Office Action Summary

10/627,225

YBARRA, LUIS M.

DETAILED ACTION

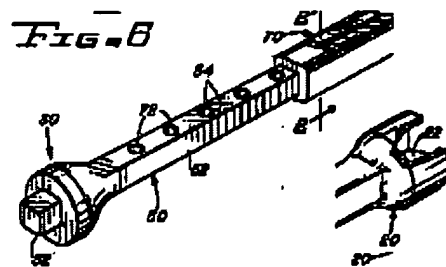
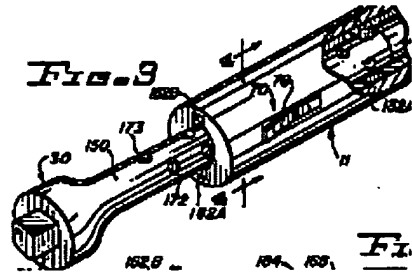
7. Claims 1-20 are rejected under 35 U.S.C. 102(b) as anticipated by or, in the alternative, under 35 U.S.C. 103(a) as obvious over Newby et al. (4,376,397) in view of McBride (4,409,86) or Mathews (4,960,015).

Newby et al. discloses all of the limitations of claims 1, 11 and 16, i.e., an adjustable extension for driving tools comprising an outer tubular member (60) (160), the outer tubular member having a proximal end and a distal end, the adjustable extension having a longitudinally extending connector (50) (150), the longitudinally extending connector having a proximal end and a distal end, the outer tubular member having a receiver (22) at the proximal end thereof for receiving a driving tool, the tubular member having a longitudinally extending central cavity, the central cavity having a non-circular cross-section, the adjustable extension further having the longitudinally extending connector adjustably received within the longitudinally extending central cavity of the tubular member for relative telescoping movement thereto, the longitudinally extending connector having its proximal end received within the central cavity of the tubular member, the proximal end of the longitudinally extending connector having a non-circular cross-sectional shape cooperating with the central cavity of the tubular member, the longitudinally extending connector having its distal end extending out of the longitudinally extending central cavity and beyond the distal end of the tubular member, the distal end of the longitudinally extending connector having a tool driving member (32), the longitudinally extending connector having an intermediate portion between its proximal and distal ends, the intermediate portion of the longitudinally extending connector being substantially circular in cross-section and being of

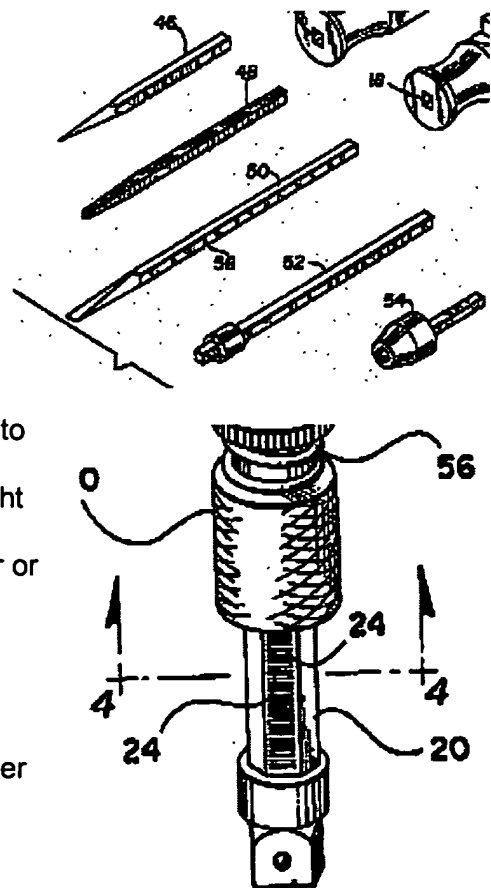
Note that the limitation of a "rack with teeth" is considered met by the (52 (72) as broadly defined, however, in the alternative, as evident by McBride, notches in form of a longitudinal slots closely placed together (Fig. 2) or teeth as defined by Mathews to engage with the pawl, are known in the art. It would have been obvious to one of ordinary skill in the art, at the time the invention was made, to modify the invention of Newby et al. with the "teeth" as taught by either McBride or Mathew to adapt the tool for more finer or smaller degree of adjustment.
